BZA Hearing July 18, 2006
Application No. 17309
Dorchester LLC

CASE NO. 17309

**STATEMENT BY RUDY DJABBARZADEH RE BZA APPLICATION NO. 17309
HEARING JULY 18, 2006**

GRAPHIC TITLE
LOT 'F' SITE SECTION

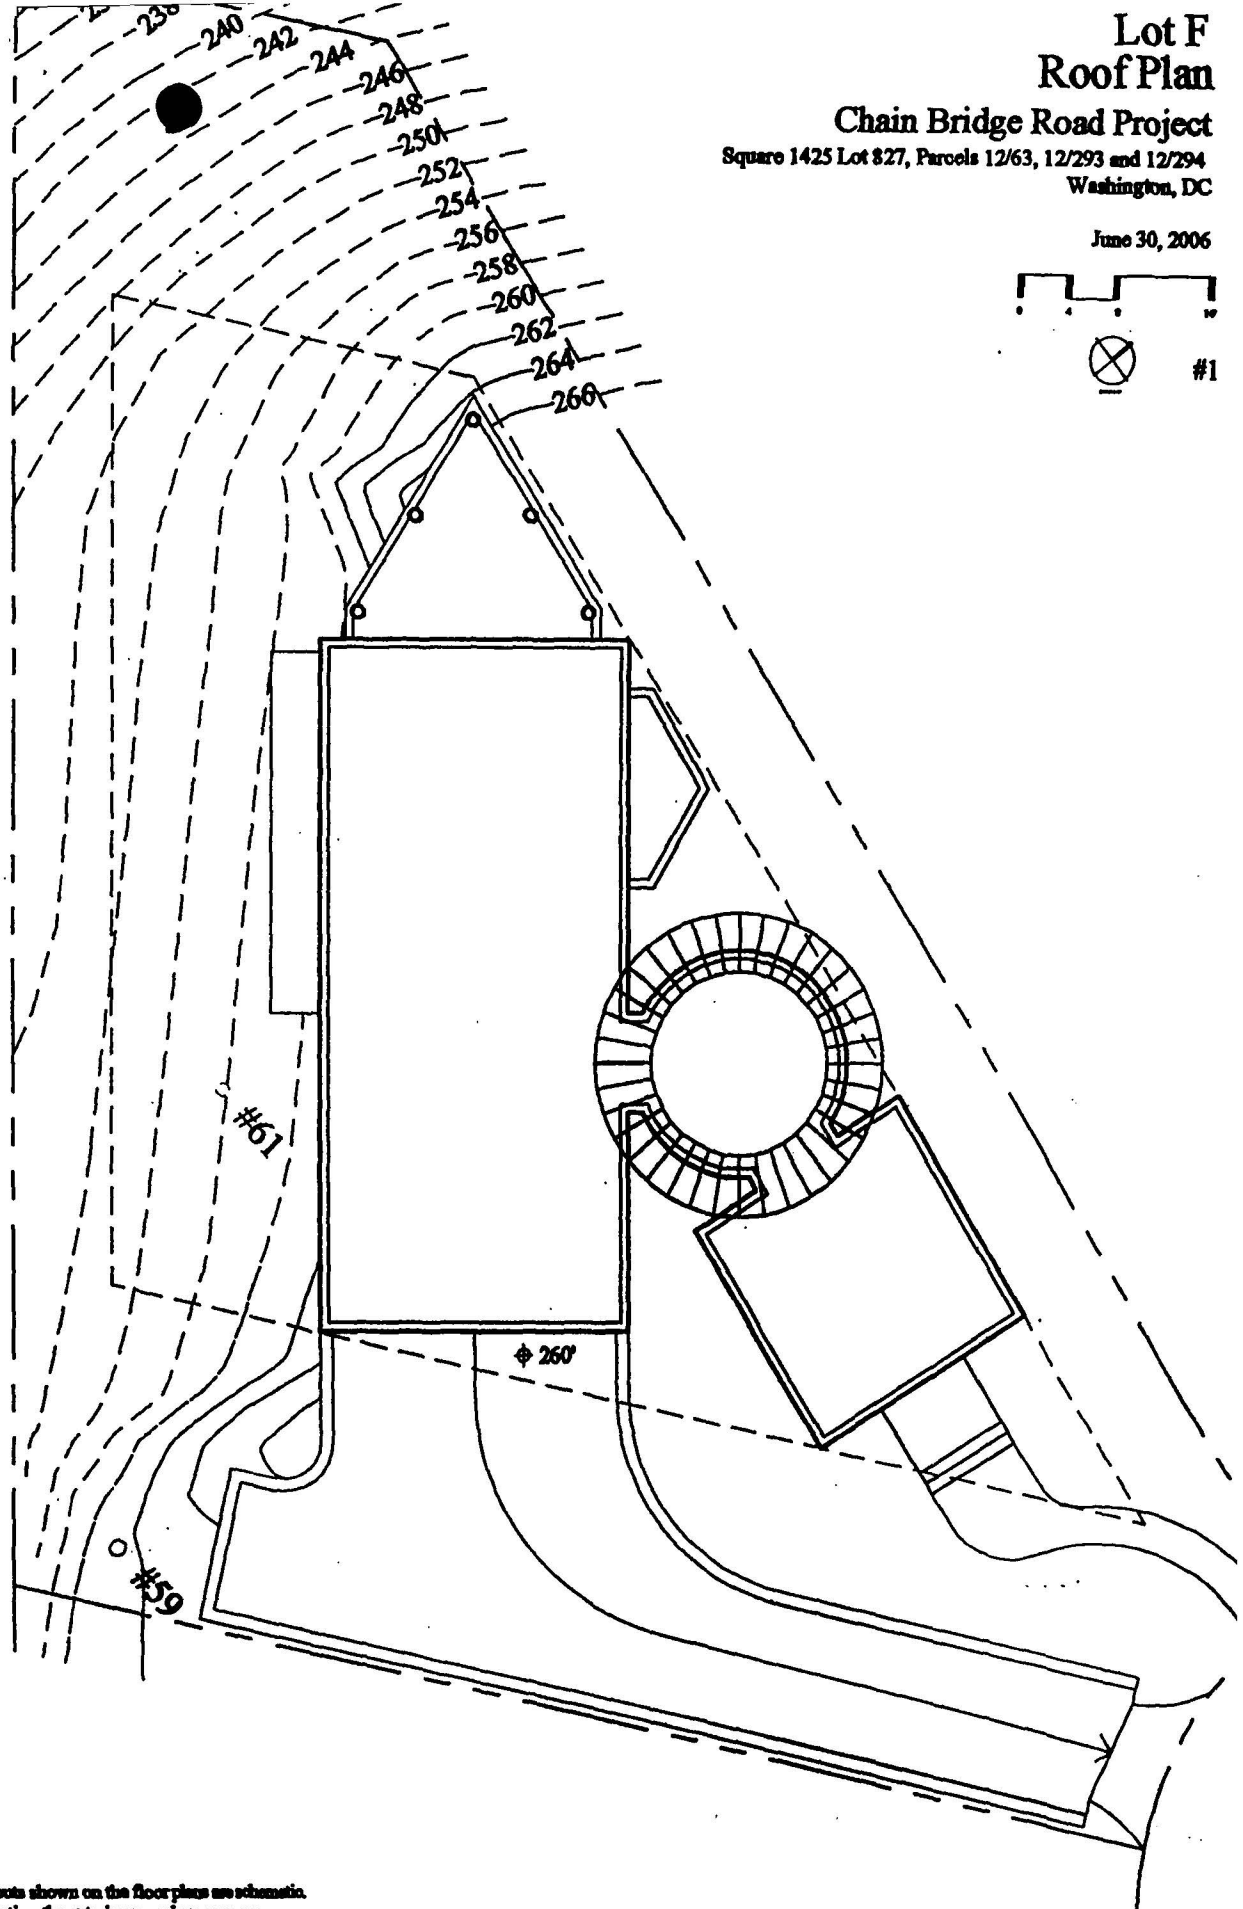
- The first set of plans for lot “F”, which is the lot contiguous with my house, showed a house to be built within ten feet of my property and to tower over my residence by fifty-two feet. After the office of planning raised multiple objections to the proposed lot F - more specifically suggesting the elimination of Lot F and the absorption of its 9,569 square feet into the adjacent lots- two different revised schematic plans were submitted, which somewhat relocated the footprint of the house and reduced its size by 200sq ft to 6,622 sq ft, but the footprint of the presently proposed house disturbs the steep slope considerably and increases the risks of collapse of earth (the slope consists mainly of fill-dirt). The pitch of the slope is at a 50% incline, which means that for every 12 horizontal inches there is a 6 inch vertical drop. This slope is currently maintained by a dense, but controlled, growth of bamboo, which also serves as a privacy screen. The argument that bamboo is invasive can be easily addressed by the implementation of a concrete barrier to stop the bamboo from spreading. Even without the existence of such a barrier in the present situation there is no problem of containment.

The submitted landscaping plan for lot F is mind boggling in its total disregard of the neighboring property. It suggests southern magnolias, hemlocks and black oak to be planted on the edge of the property, on top of my 8' high retaining wall, the canopies of these trees would invade my property, depriving the property of light and causing major maintenance issues. The existing bamboo would serve the privacy for both lot F and my property, while effectively controlling the slope. Why replace something that is perfectly functional with something inadequate?

LOT 'D'
SOUTH ELEVATION
0 4 8 16 32'
SEPTEMBER 23, 2003

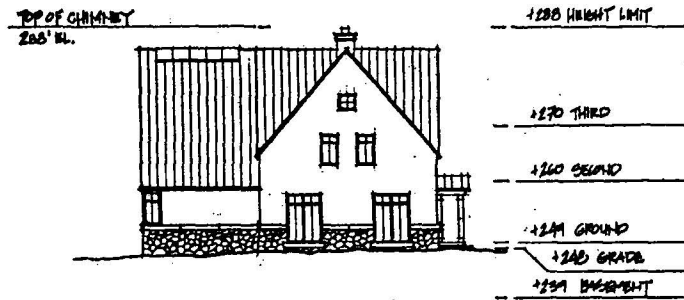
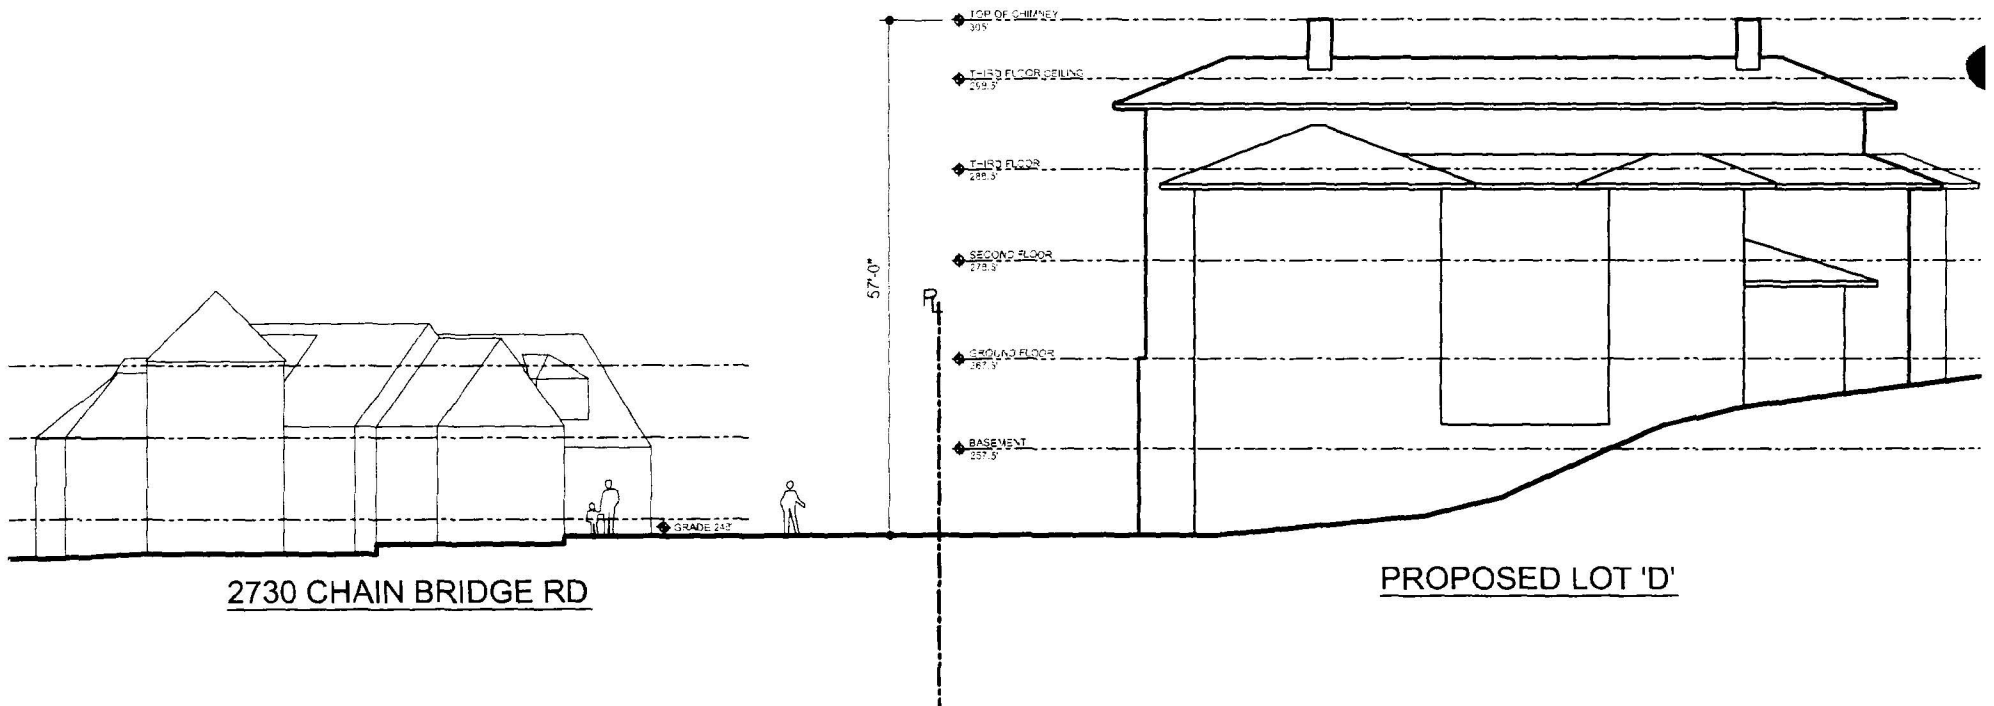
- The issues with proposed **Lot “D”** are self evident. As you see in the pictures the house on lot D, which is over 10,000 square feet, will tower 57’ over the 2730 Chain Bridge Rd. house while the horizontal distance between both houses is barely 50’! The development of this lot requires the removal of a 48’ high healthy magnolia (tree #35).
